**6622A-12**

# S E R V I C E N O T E

## 6622A DC Power Supply

### Intermittent Power Transformer “Magma” Connections

**Top View of Power Transformer:**

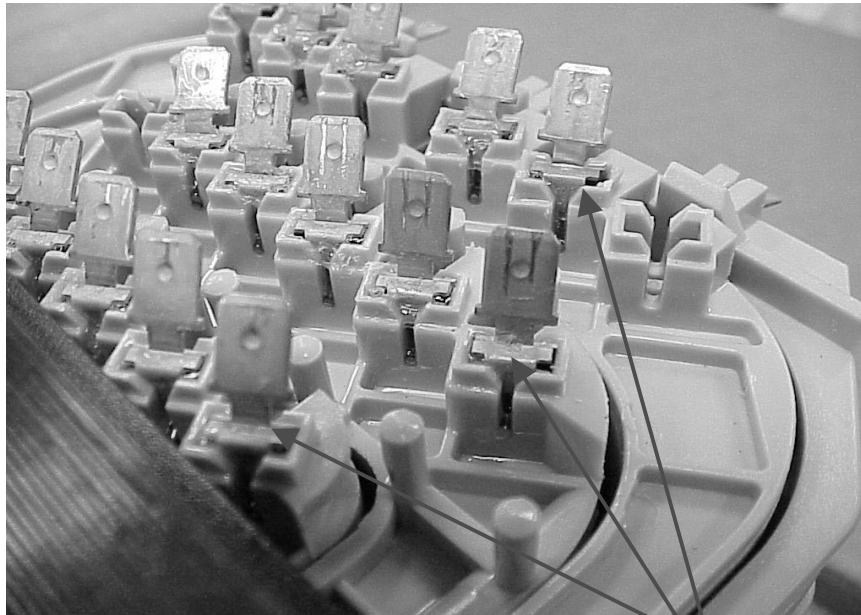
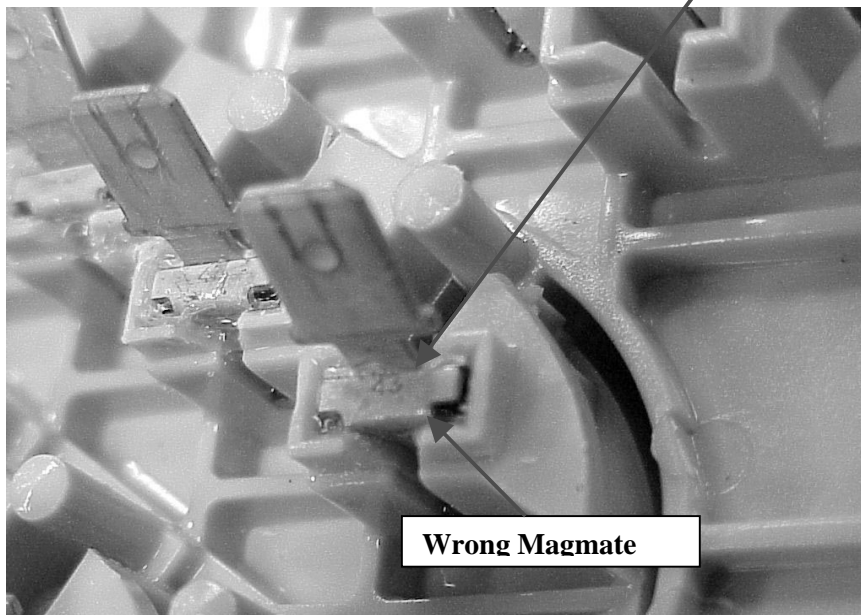
The power transformer vendor mistakenly installed the wrong “Magmates” in a run of power transformers. The incorrect “Magmates” have a # 43 stamped on them, which corresponds to a 15 gauge wire size. The correct size “Magmate” should be # 24 designed for a 19 gauge wire size.

This could result in a variety of intermittent as well as steady hardware problems and errors. Examples: HDW ERR CH 1, Blank front panel display, not meeting specifications.

**Incorrect “Magmate” number 43 on the Surface, This should be number**

**Wrong Magmate**

Replace the Power Transformer with a new replacement Transformer, see the table above for the correct power transformer part number.

**NOTE:** Please inspect the new transformer for the correct “Magmate” number stamping.
